# Wisconsin Department of Transportation

**Proposal #07: 4492-03-71, WISC 2020 384**  
**Racine Street Bridge, C of Menasha**  
**Fox River Bridge and Approaches**  
**Local Str**  
**Winnebago County**

This is Addendum No. 01, which provides for the following:

**ADDENDUM NO. 01**  
**PROJECT ID 4992-03-71**  
**July 30, 2020**

Addendum No. 01  
 ID 4992-03-71  
 Revised Sheet 15  
 July 30, 2020

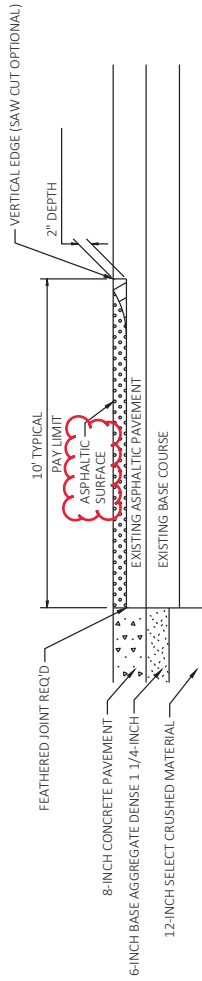
| Revised Plan Sheets |   |
|---------------------|---|
| 15                  | Construction Details (revised pavement type)                                  |

Addendum No. 01  
ID 4992-03-71  
Revised Sheet 550  
July 30, 2020

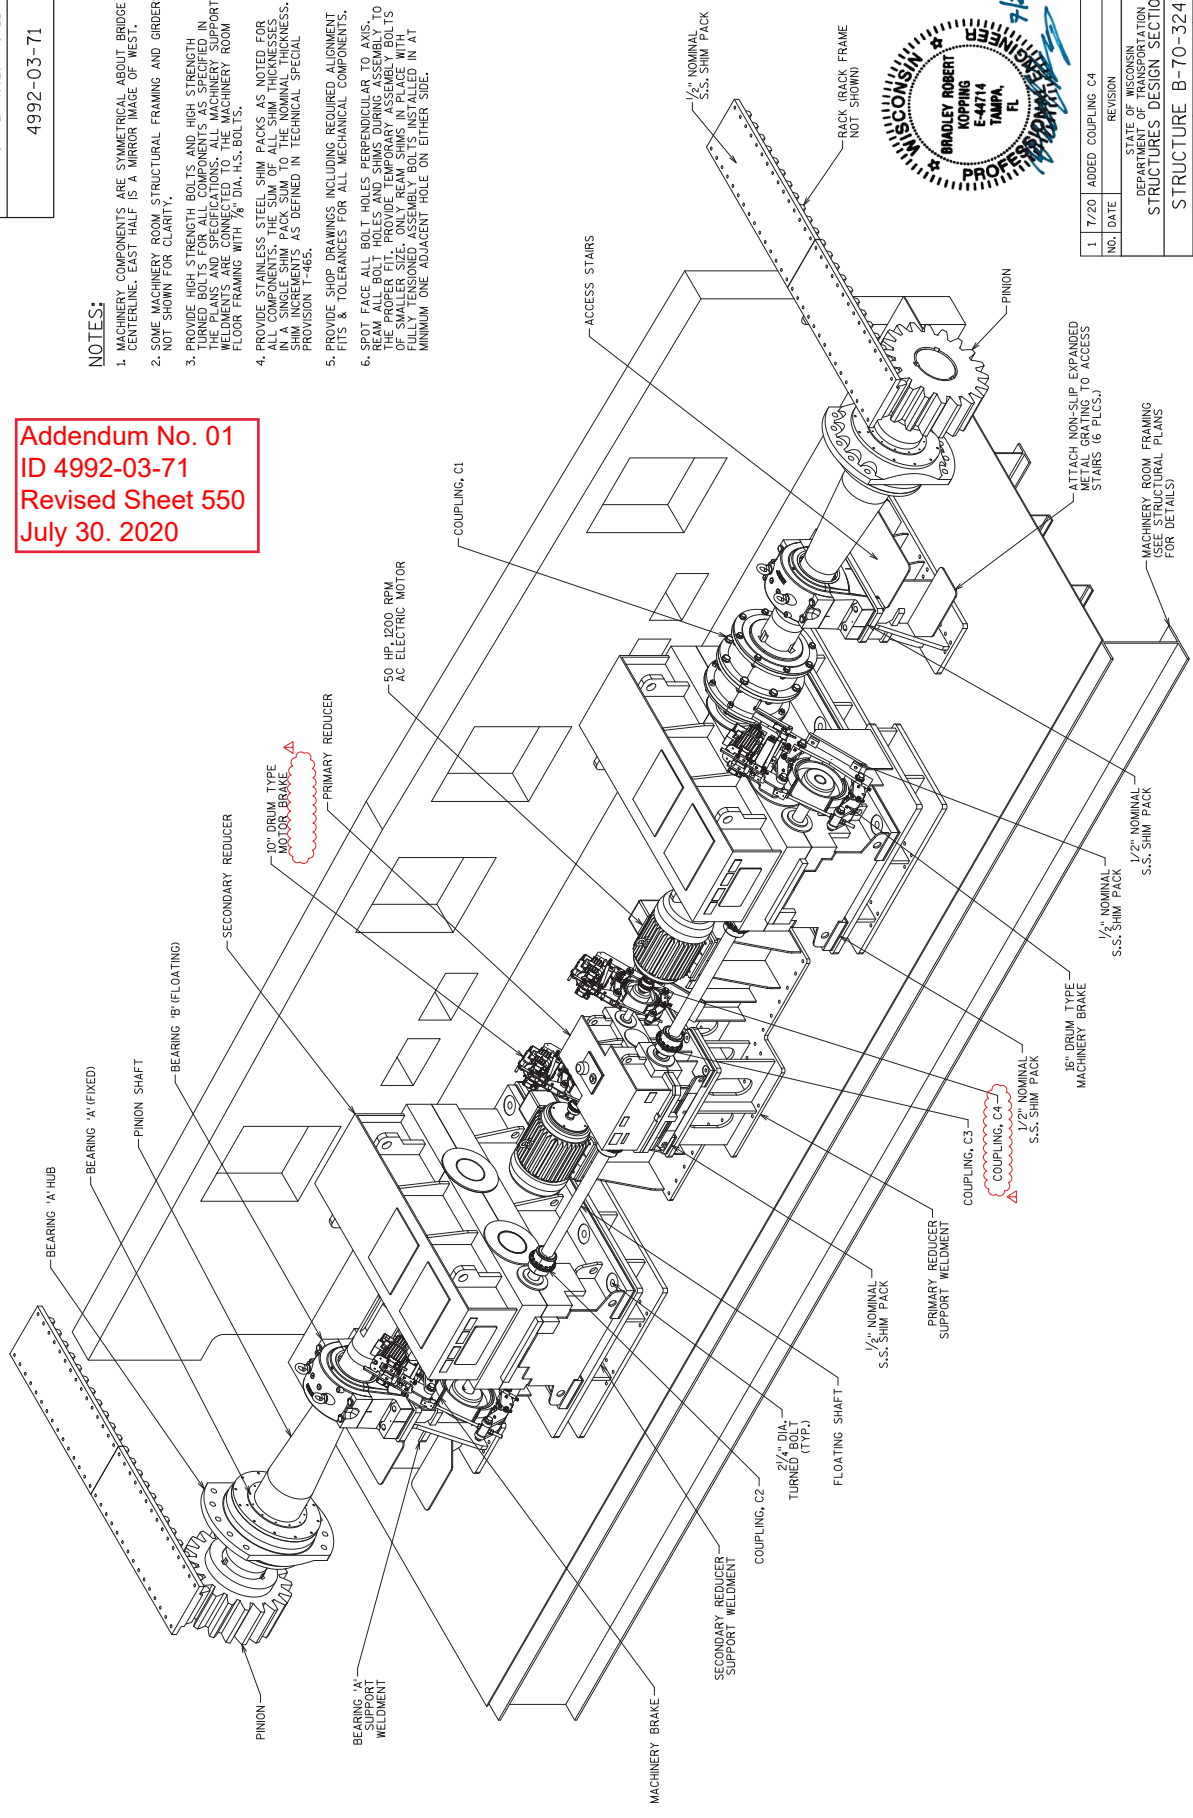
| Revised Plan Sheets |   |
|---------------------|---|
| 550                 | Machinery Trimetric View (revised coupling notes)                             |

| 1   | 7/20 | ADDED COUPLING C4 |     |    |

Addendum No. 01  
ID 4992-03-71  
Revised Sheet 551  
July 30, 2020

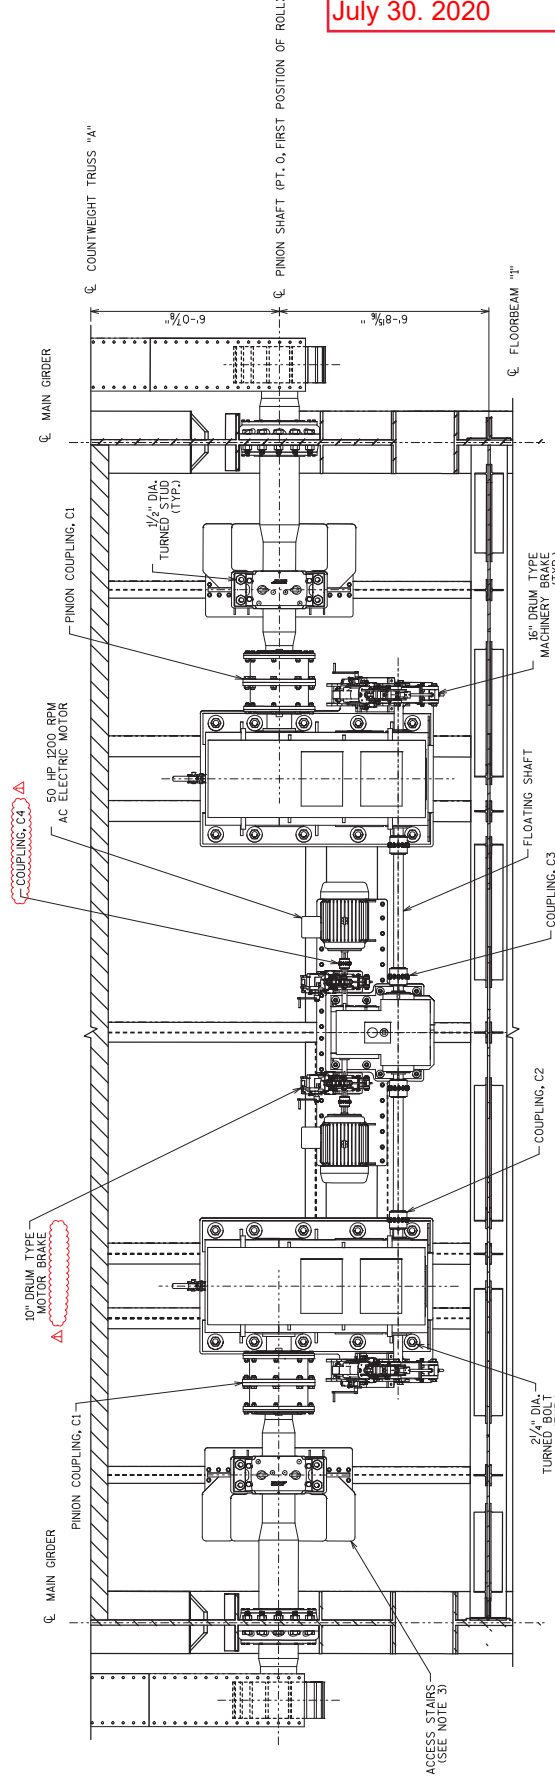
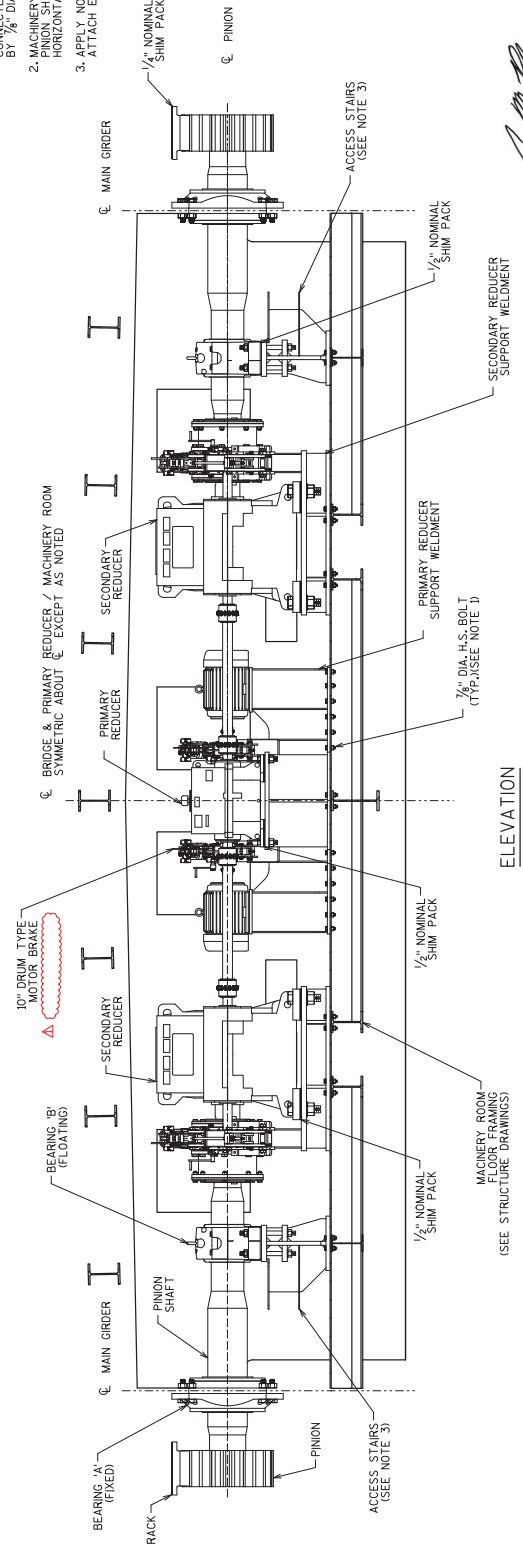
| Revised Plan Sheets |   |
|---------------------|---|
| 551                 | Machinery Plan and Elevation (revised coupling notes)                         |

| 1   | 7/20 | ADD COUPLING C4, BRAKE DESC. | JCU |    |

Addendum No. 01  
ID 4992-03-71  
Revised Sheet 552  
July 30, 2020

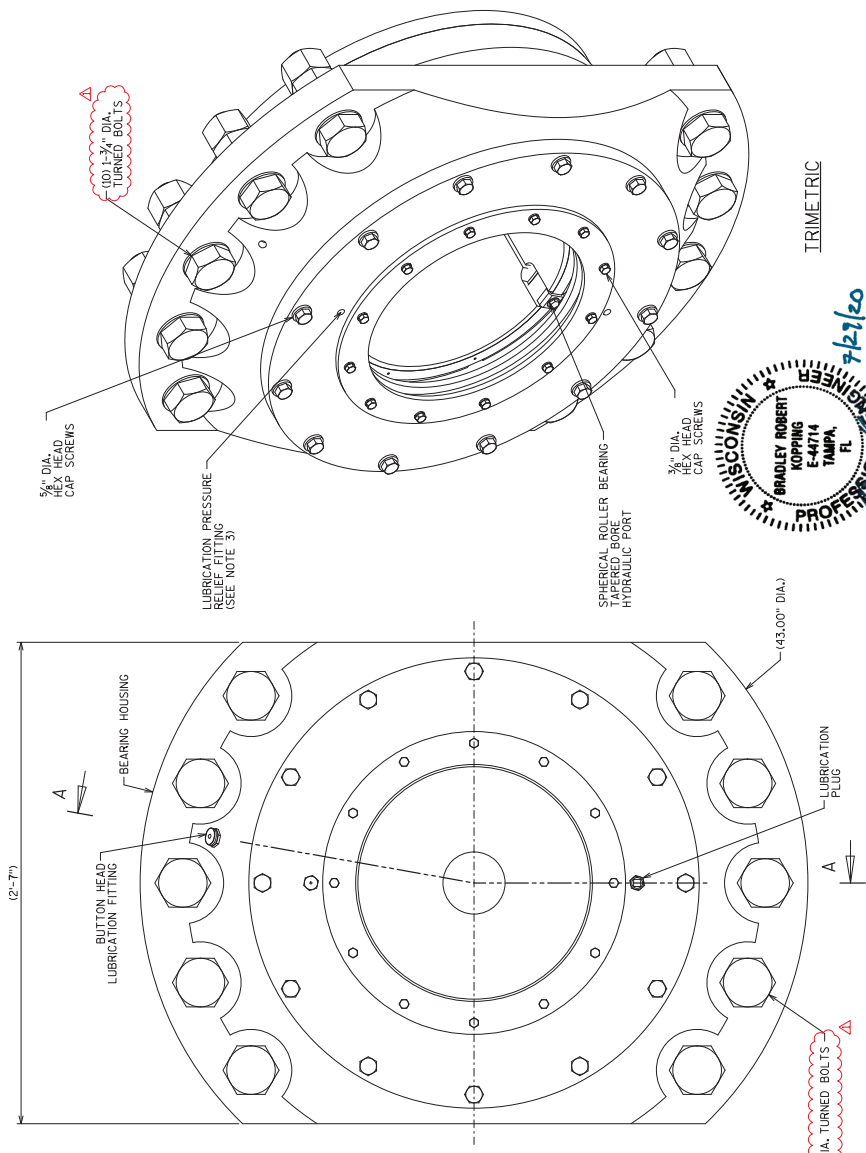
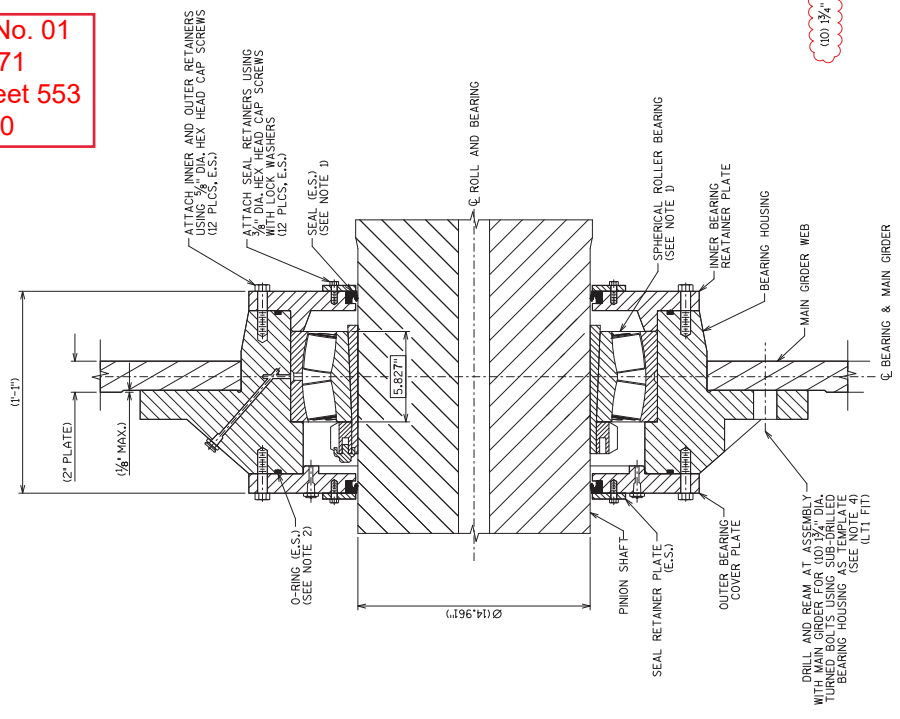
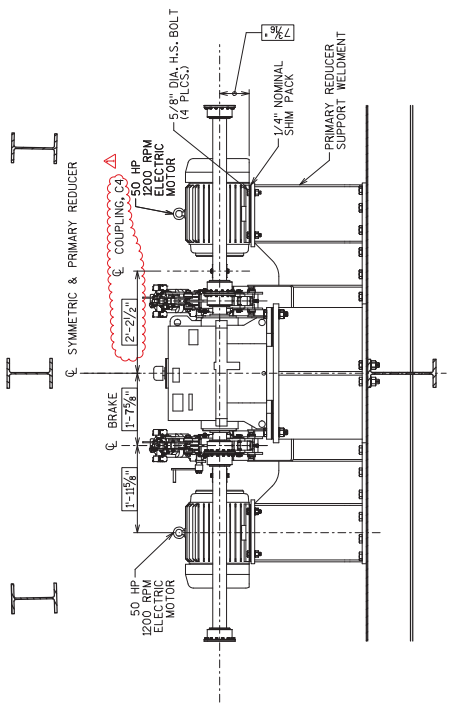
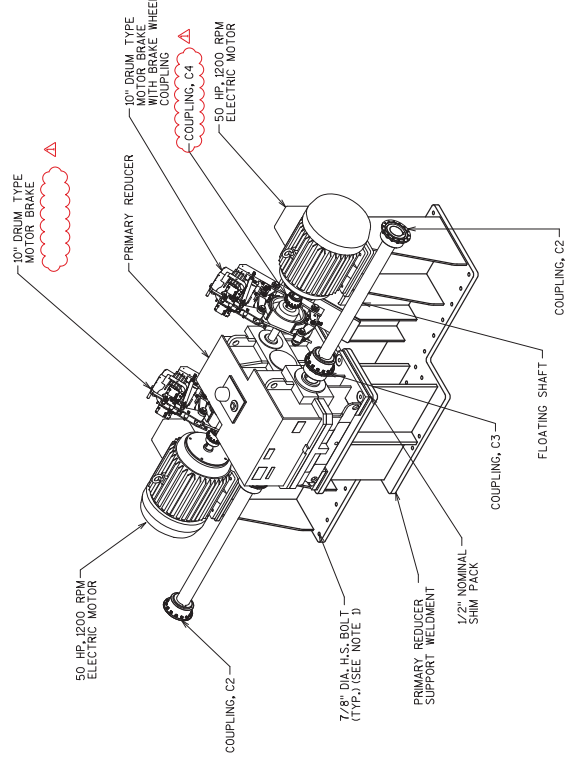
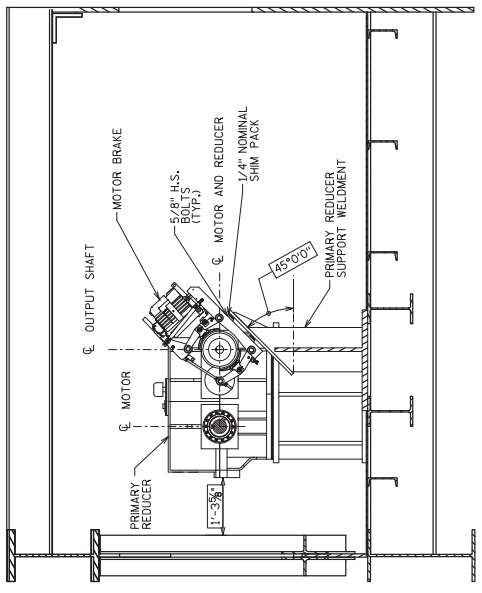
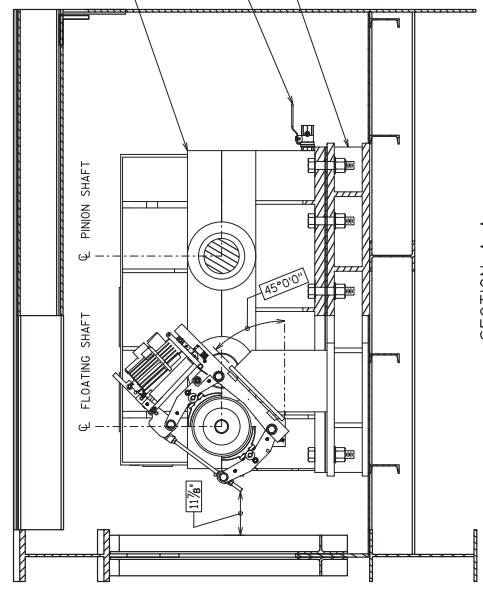
| Revised Plan Sheets |   |
|---------------------|---|
| 552                 | Machinery Plan & Elevation 2 (revised coupling notes)                         |

| NO.   | DATE | ADDED COUPLING C4, BRAKE DESC. | JCU                  | BY  |

Addendum No. 01  
ID 4992-03-71  
Revised Sheet 572  
July 30, 2020

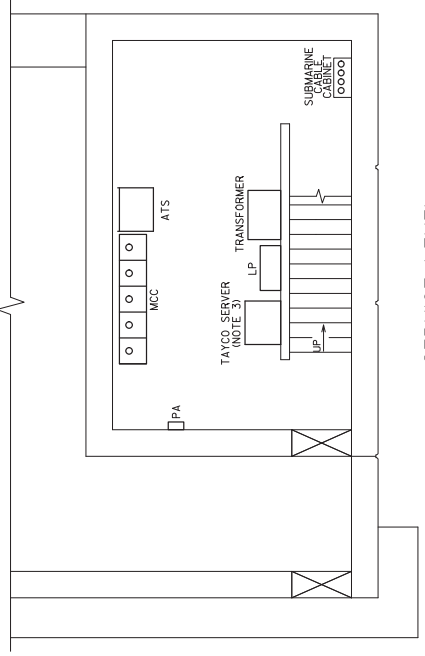
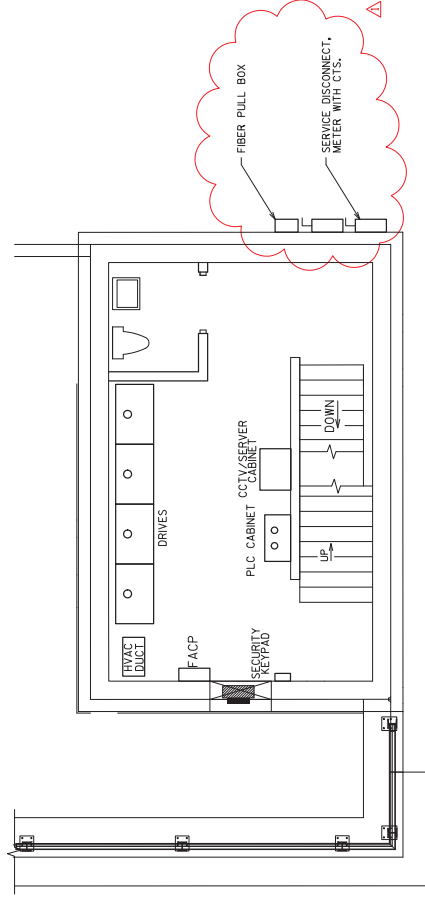
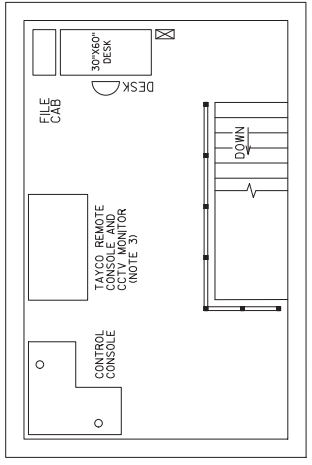
| Revised Plan Sheets |   |
|---------------------|---|
| 572                 | Operator's House Electrical Floor Plans (revised north arrow and added notes) |

| 1   | 07/22/20 | REVISED NOTES, CALLOUTS, AND NORTH ARROW | HVP |

Addendum No. 01  
 ID 4992-03-71  
 Revised Sheet 574  
 July 30, 2020

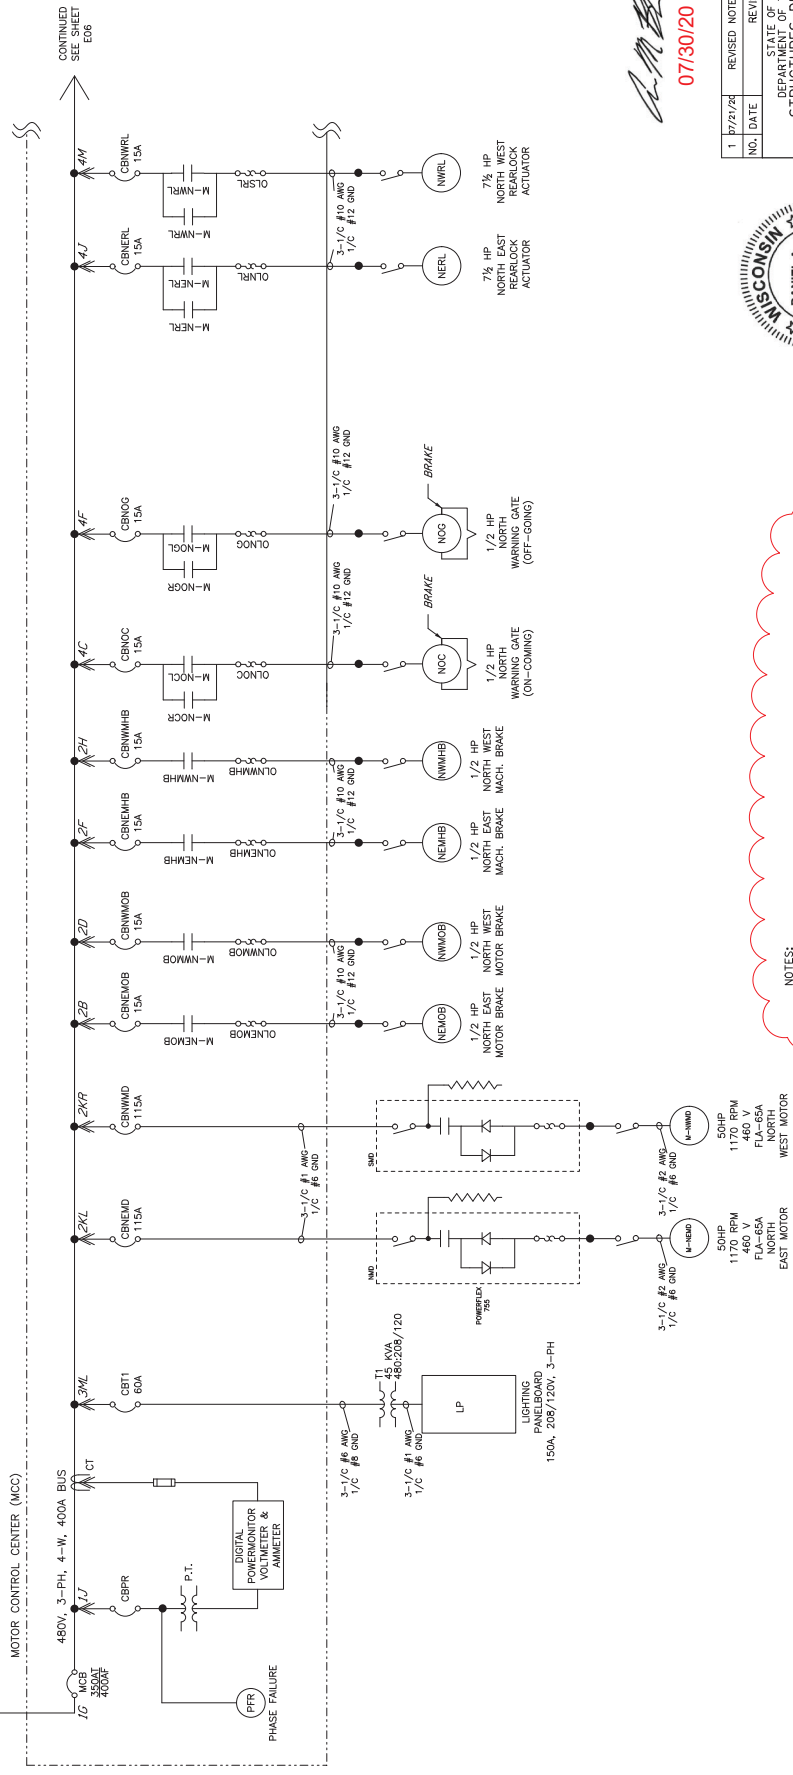
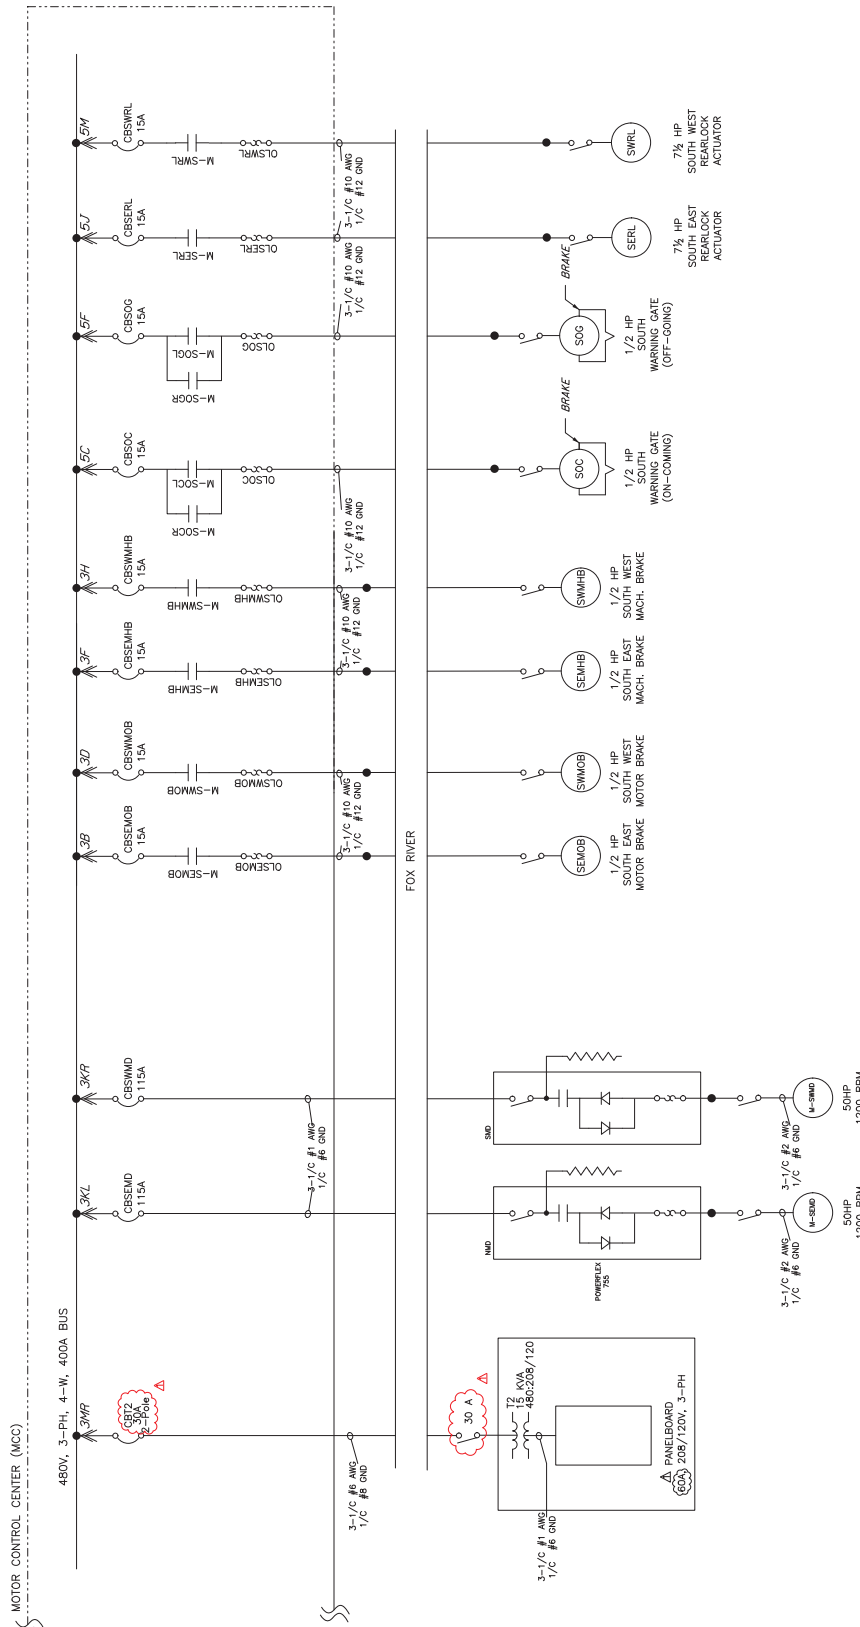
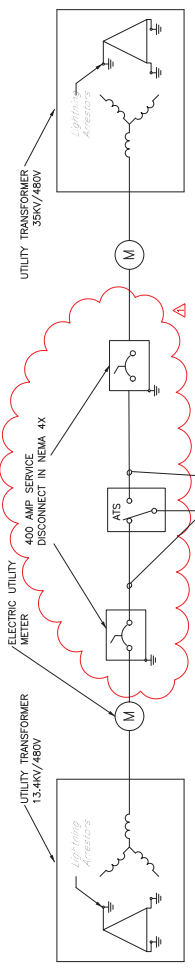
| Revised Plan Sheets |   |
|---------------------|---|
| 574                 | Single Line Diagram (1 of 2) (revised 400 amp service and notes)              |

| NO.   | DATE     | REVISION                 | HVP     | BY  |
|---|----------|--------------------------|---------|-----|
| 1   | 07/21/20 | REVISED NOTES & CALLOUTS |         |     |

**Addendum No. 01**  
**ID 4992-03-71**  
**Revised Sheet 575**  
**July 30, 2020**

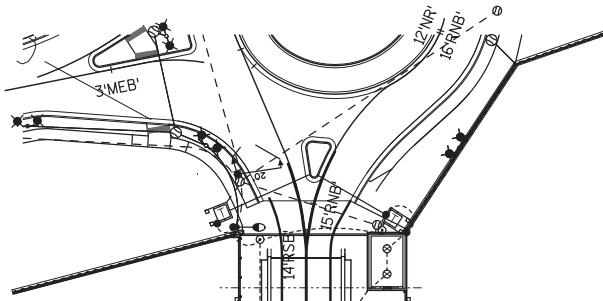
| Revised Plan Sheets |   |
|---------------------|---|
| 575                 | Single Line Diagram (2 of 2) (revised amperage and disconnect)                |
